Yuba Community College District

New Softball Field

ADDENDUM NO. 1

Thursday, June 29, 2023

3 DETAIL PLAN SCALE 1" = 10'-0"

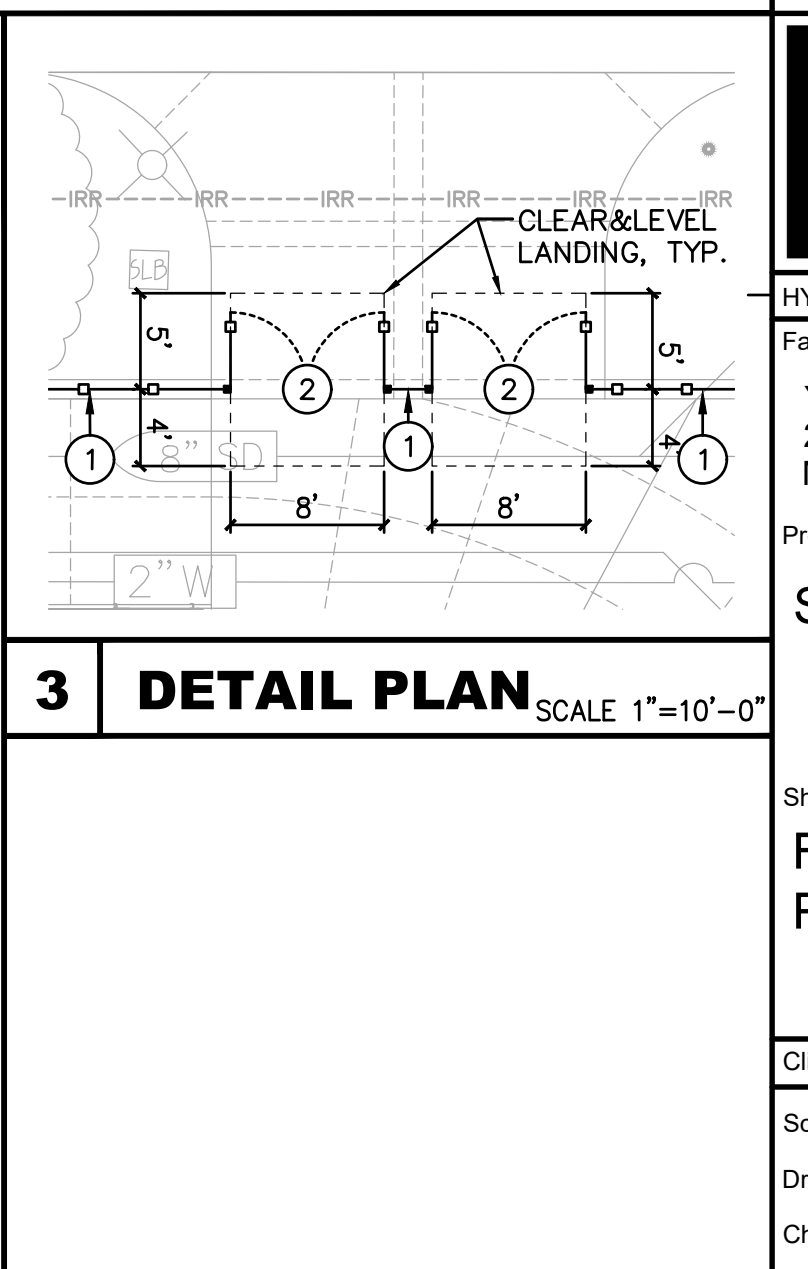
- A. **REVISE** Home and Visitors bullpen from dual to single pitching lanes.
- B. **REVISE** fencing and gate limits at both bullpens. See view 'A' and detail views '1' and '2'.
- C. **REVISE** keyed note 65 to reflect reduction of netting system height from 30' to 20'.

4 NETTING SYSTEM FOOTING NO SCALE

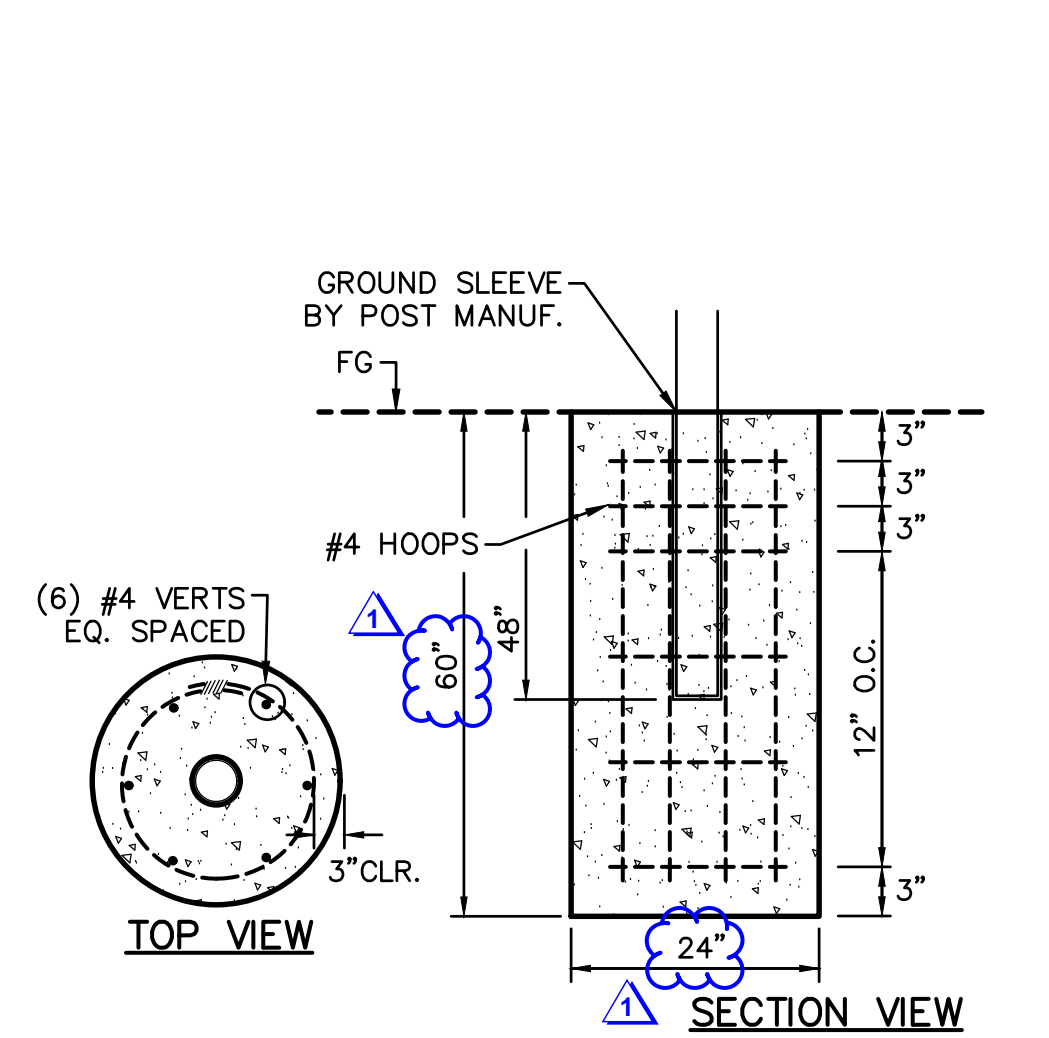
- A. **REVISE** detail 4 to reflect reduction of netting system footing size. Dimension reduced, but no changes to rebar.
- B. **REVISE** detail 5 to reflect manufacturer's standard details for 20" tall netting and posts system in lieu of 30' system.

Scale: Sheet
 Drawn By: PL
 Checked By: PL
 Issue Date: 12/16/22
 Revit Version: 2023
L1.1
 Sheet of

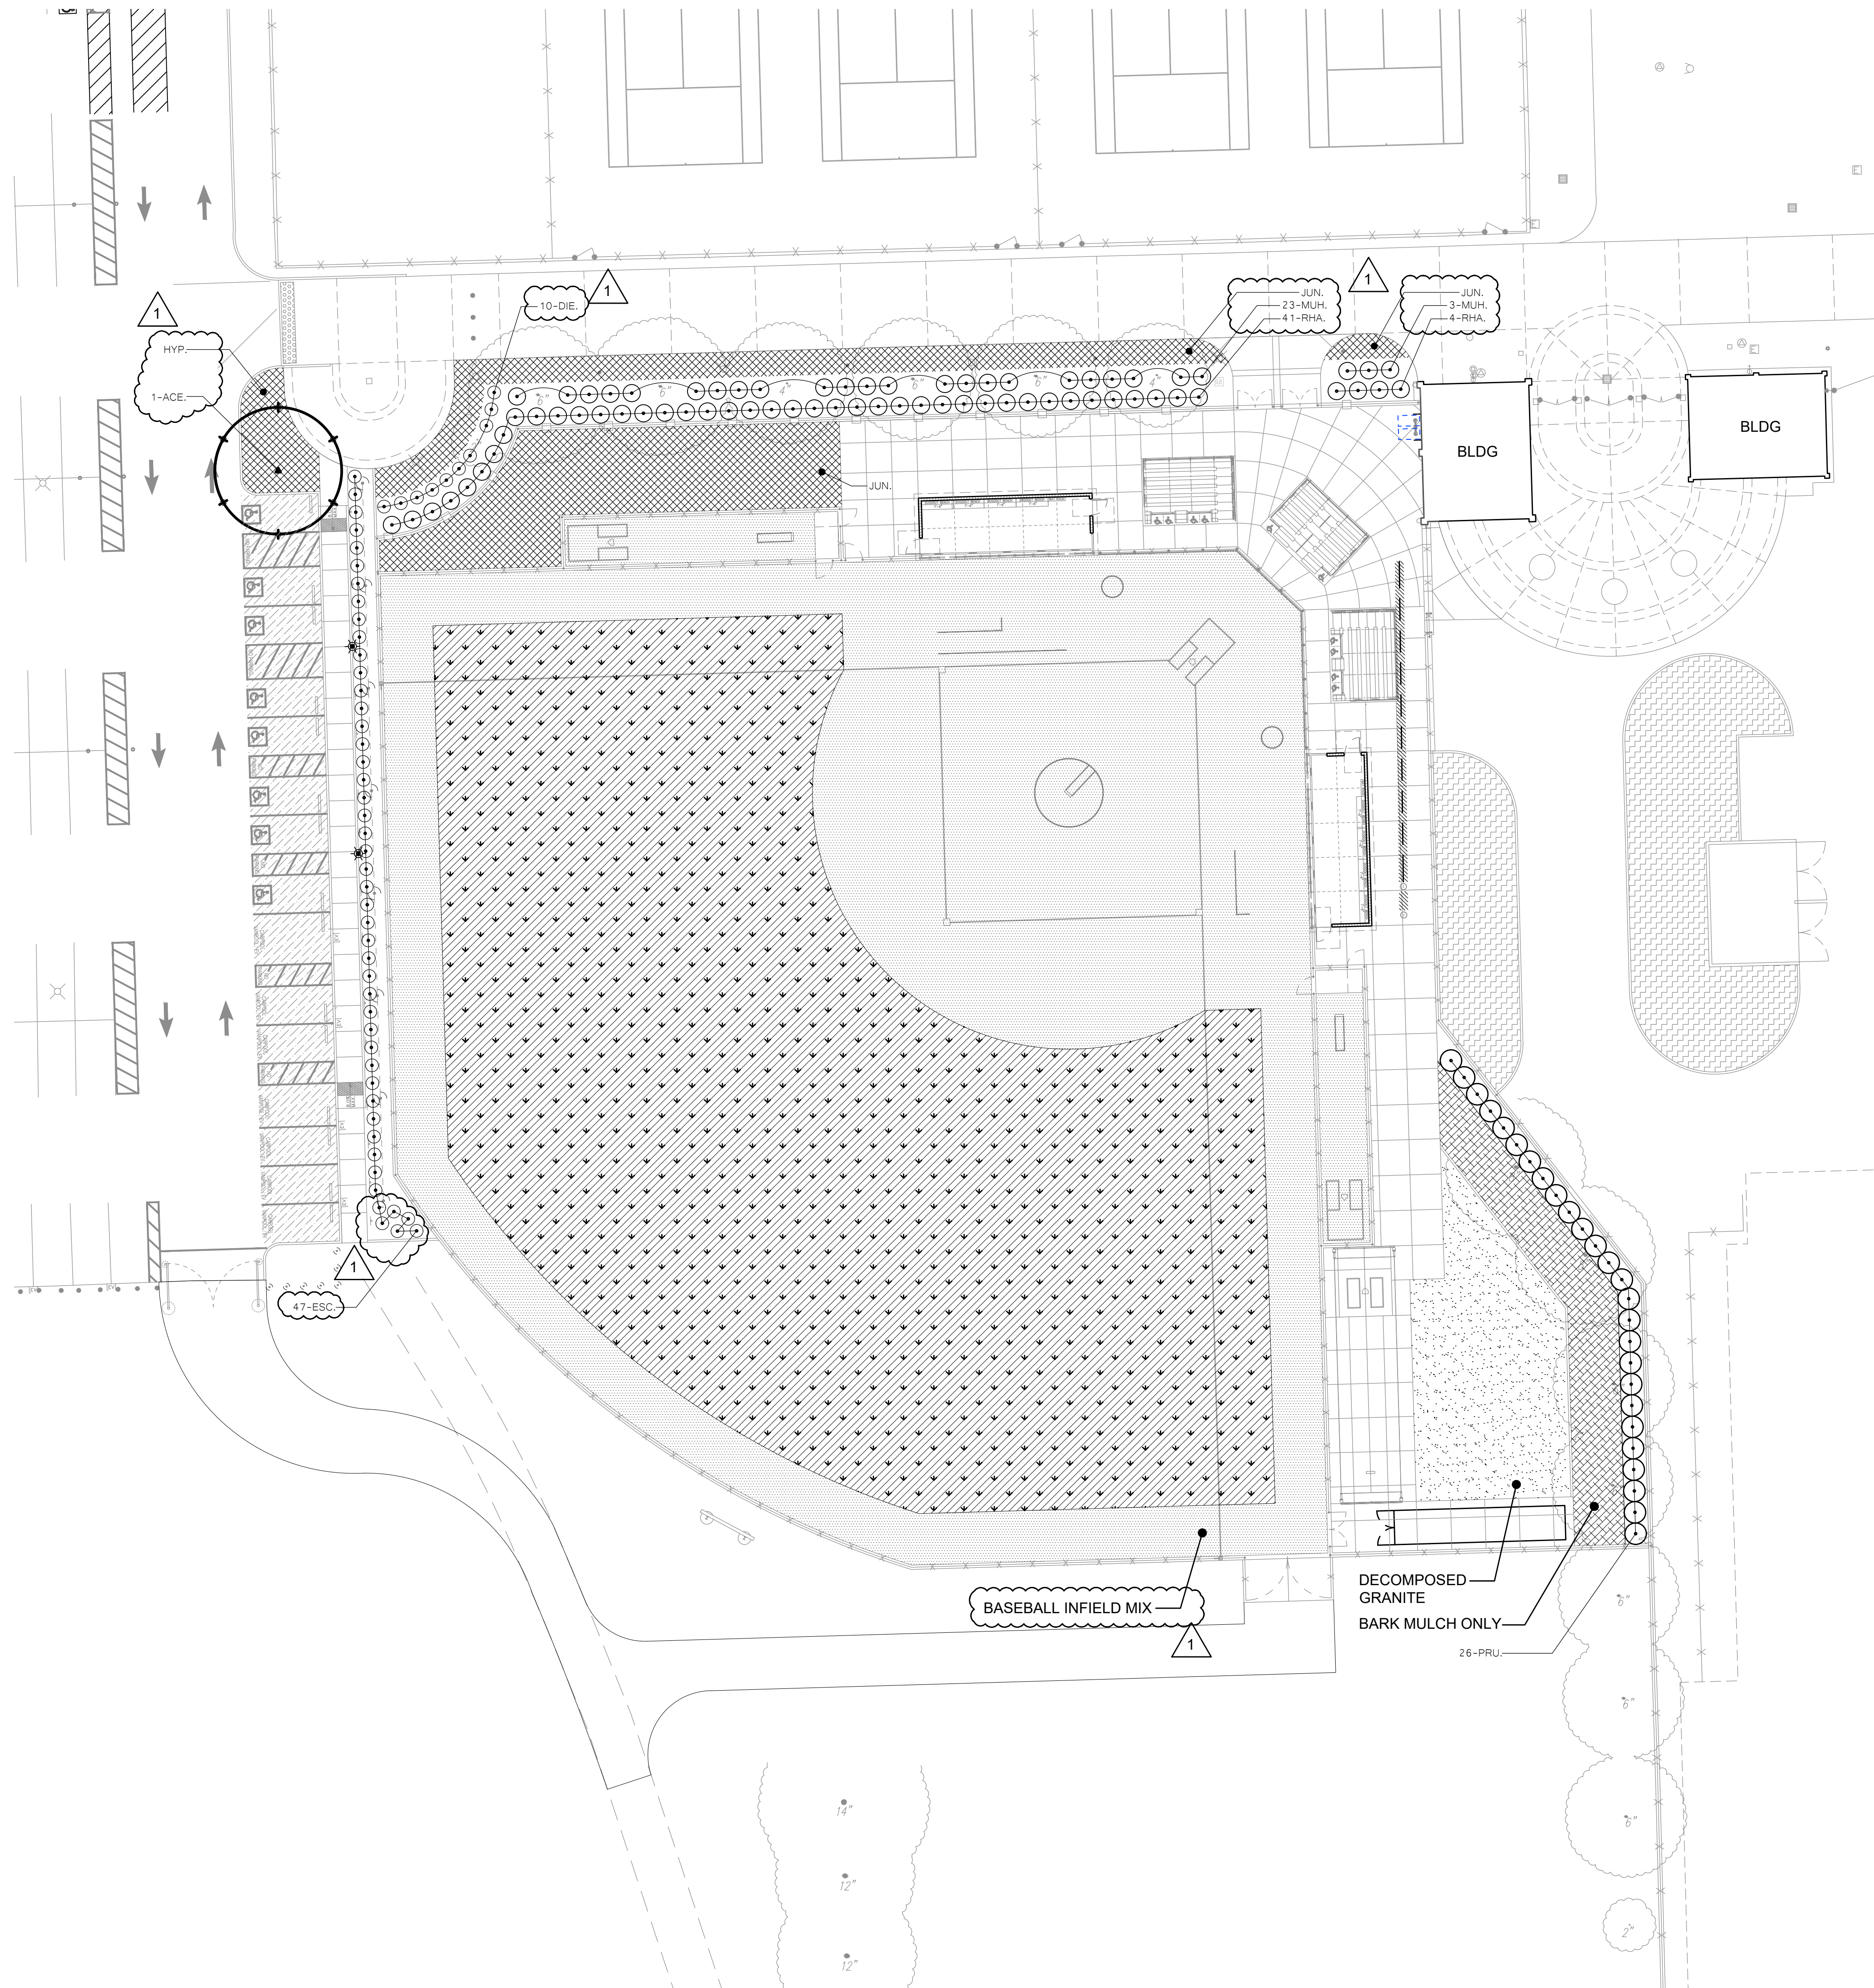
- A. **ADD** plant materials along the northern walkway.
- B. **REVISE** plant materials along the accessible parking.
- C. **REVISE** plant materials list and notes.
- D. **ADD** infield mix call out to the plan.

Client Project Number: Client Proj. #
Scale: Sheet
Drawn By: PL
Checked By: PL
Issue Date: 12/16/22
Revit Version: 2023
Sheet of
L2.1

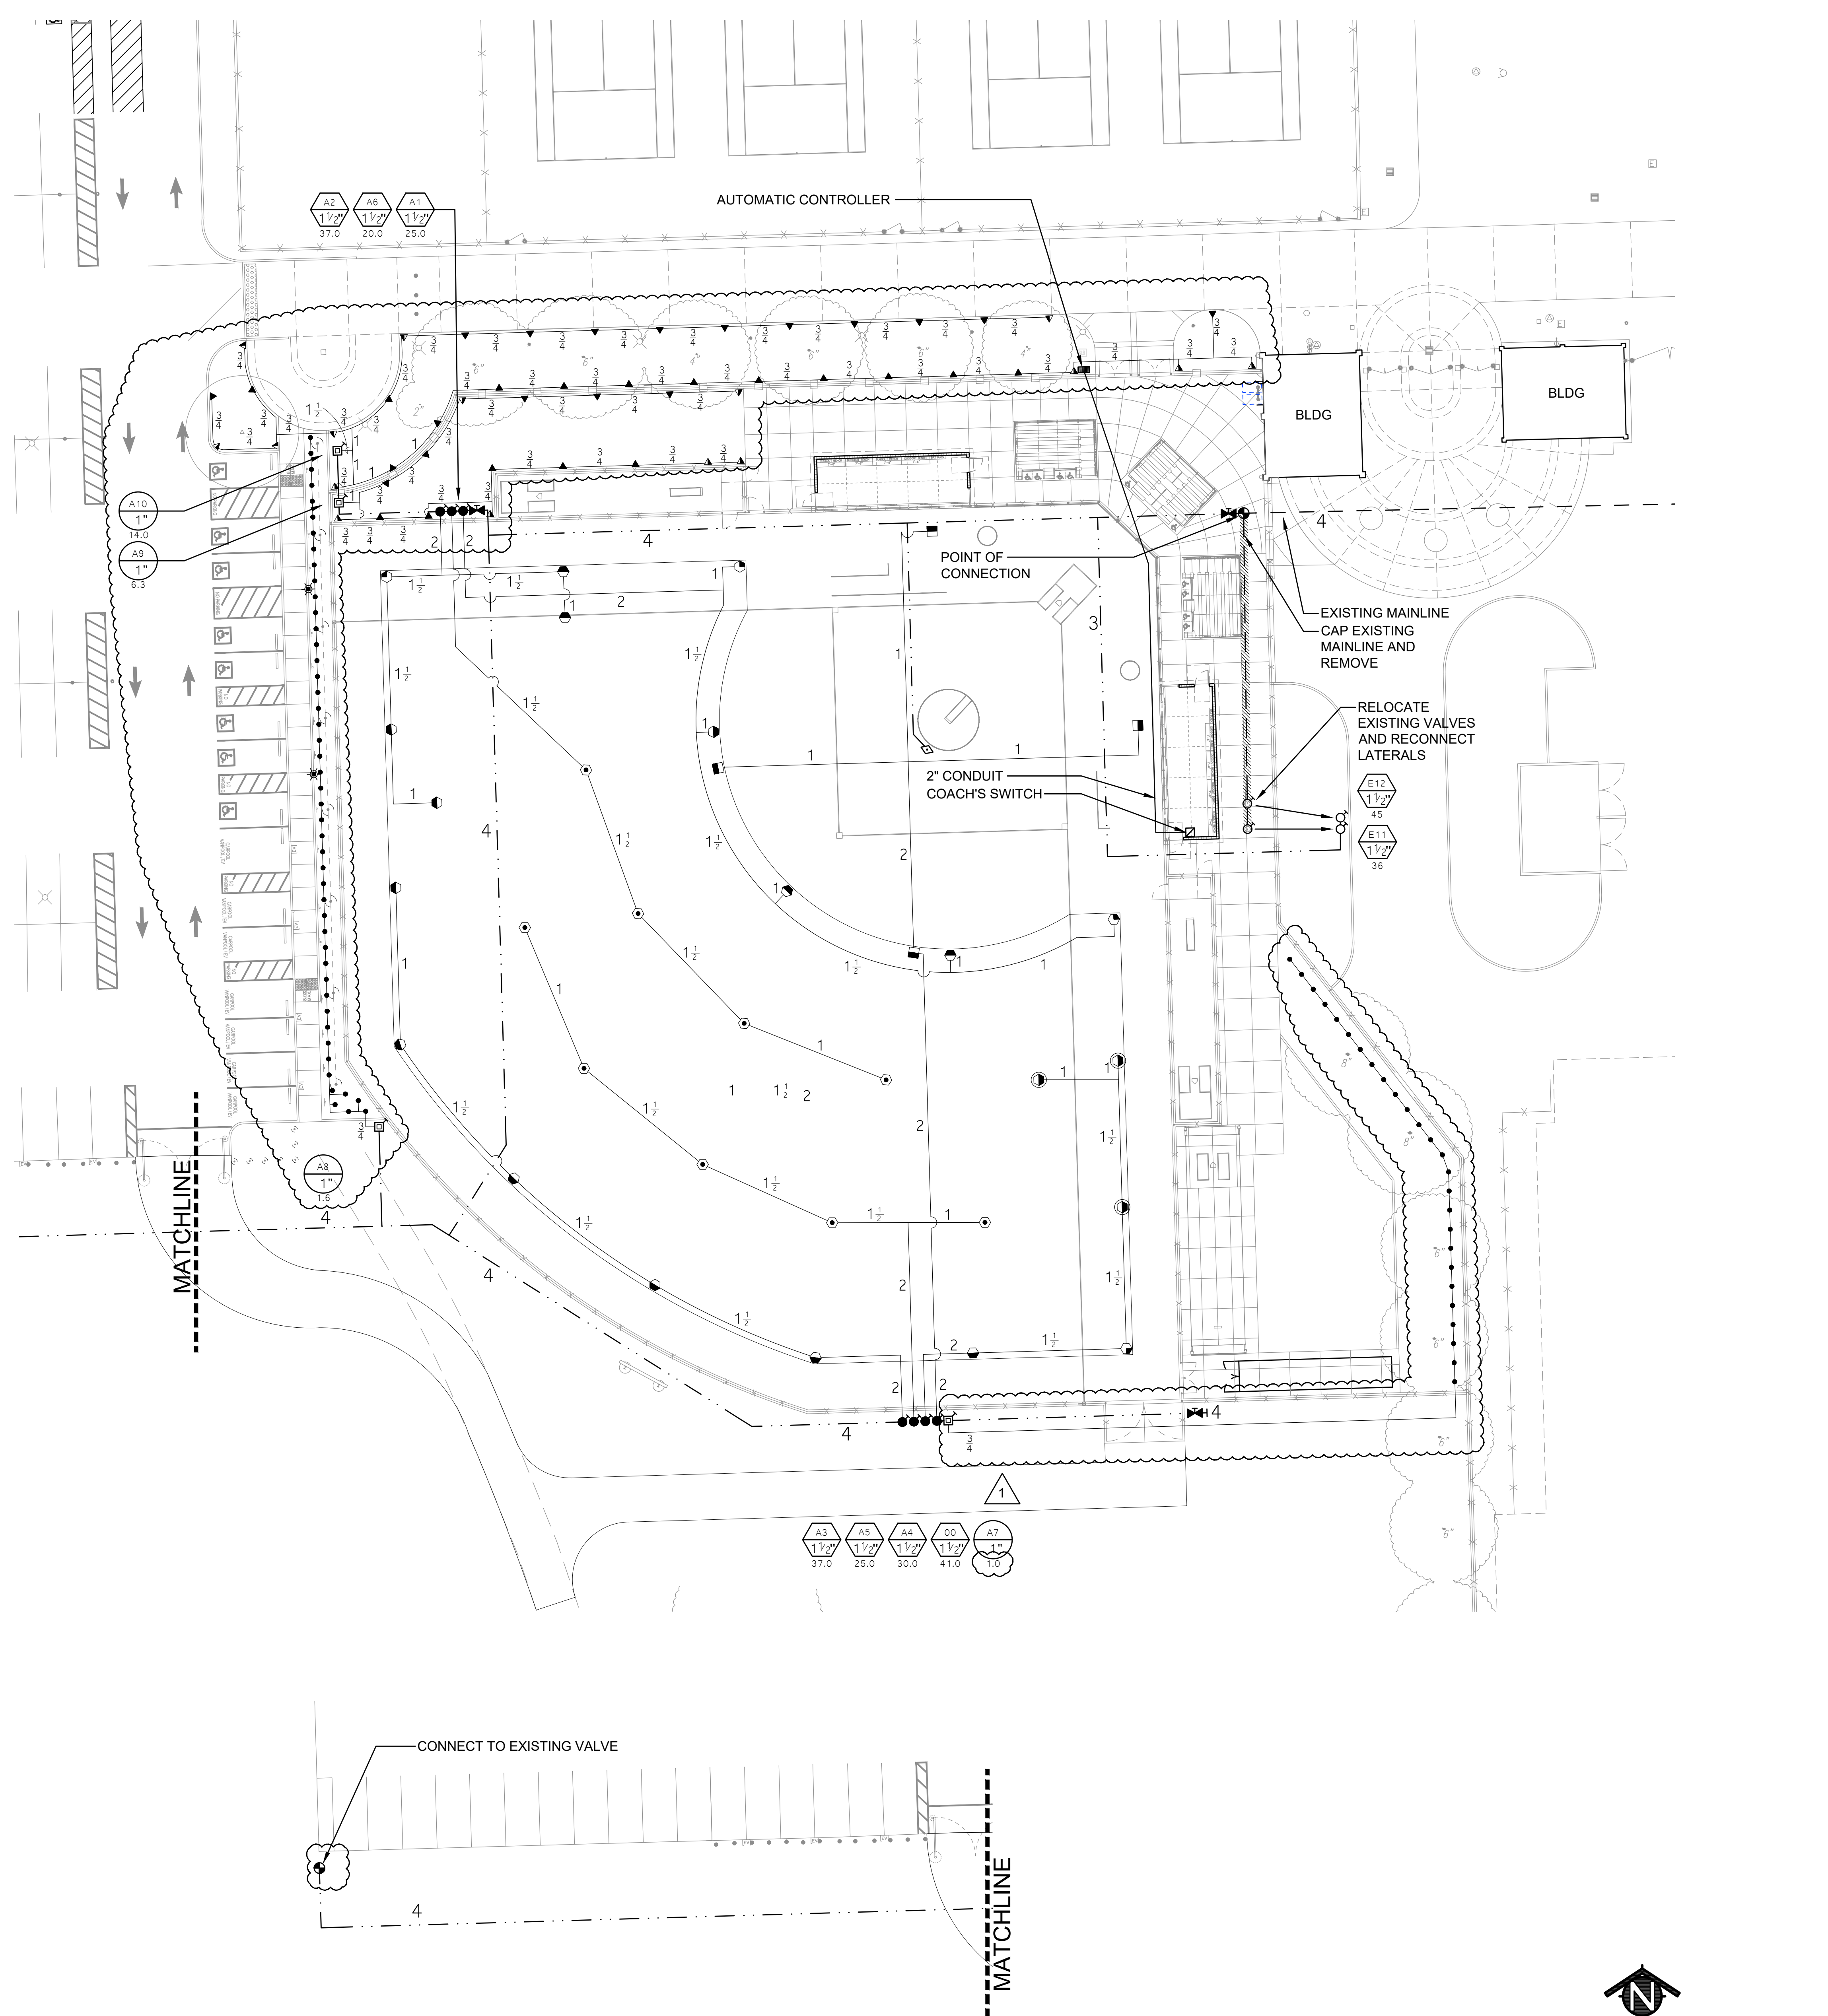
- A. **REVISE** irrigation legend and notes.
- B. **ADD** irrigation for shrub planting.
- C. **ADD** POC symbol indicating connection location at the existing valve at corner of the parking lot.
